Subject: Caldwell Parish - Hurricane Creek (11-11-584E) MVK-2011-1213

HYDROLOGY AND HYDRAULIC STUDY

HURRICANE CREEK
CALDWELL PARISH, LOUISIANA

**CONDITIONAL LETTER OF MAP REVISION
COMMENT DOCUMENT**

Figure 45: Lidar Data at Point Alt. 2-2

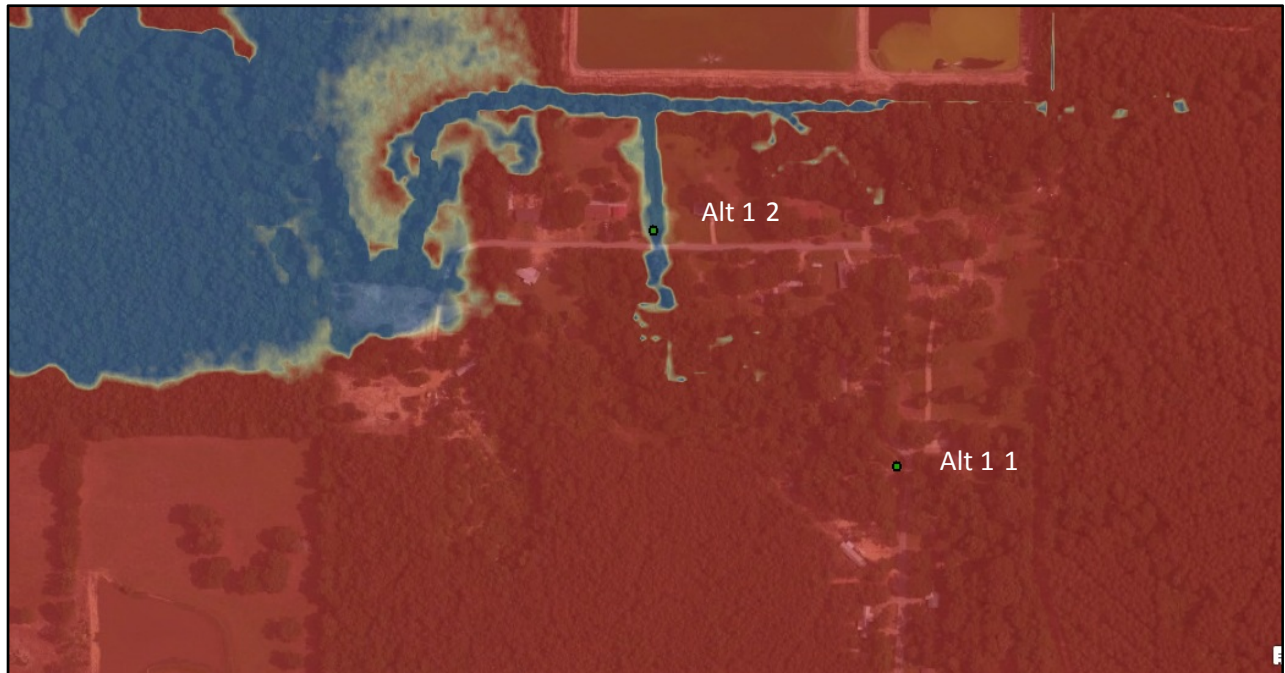
4. The H&H Study is dated March 14, 2018.
5. Figure 45 should be labeled Point Alt. 1-2, which is on the Hanchey Road tributary.
6. The project manager has obtained temporary easement/access from the majority of land owners within the project area. For the couple properties that he doesn't have a signed agreement for, the Police Jury will be using the Louisiana Attorney General's opinion that allows for the Police Jury to maintain drainage channels with a 100 ft. access easement on each side of the creek.
